Access Compliance Report Public Rights-of-Way (Curb Ramps)

Intersection ID: 21505 Main Street: COTILLION_AV Cross Street: REBEL_DR Location: E

ADA ID: 7B7E76BCF3E8 Ramp Type: Directional1 Initial Pass/Fail: Fail Overall Compliance: No Severity Score: 1.25

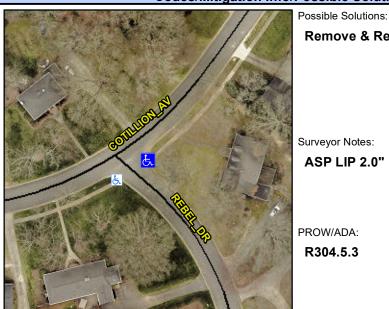
Surveyor Notes:
ASP LIP 2.0"

PROW/ADA:
R304.5.3

Remove & Replace Entire Ramp.
